PREVOST

WARRANTY BULLETIN

WB13-49

DATE :	JULY 2013	SECTION : 04 - Exhaust
EXPIRATION:	JULY 2015	
SUBJECT :	UREA QUALITY SENSOR 21891229 REPLACEMENT

Figure 1 : UQS 22073036 Pin-out

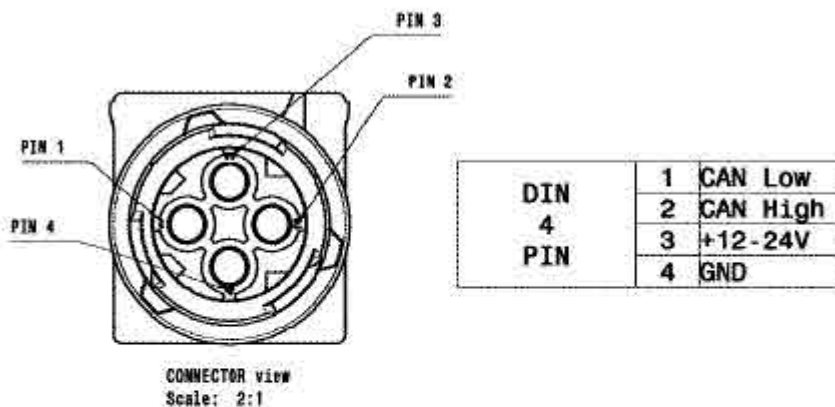
3. Modify connector pin out according to FIGURE 2.
4. *Protect with a plastic bag to avoid any DEF contamination.*
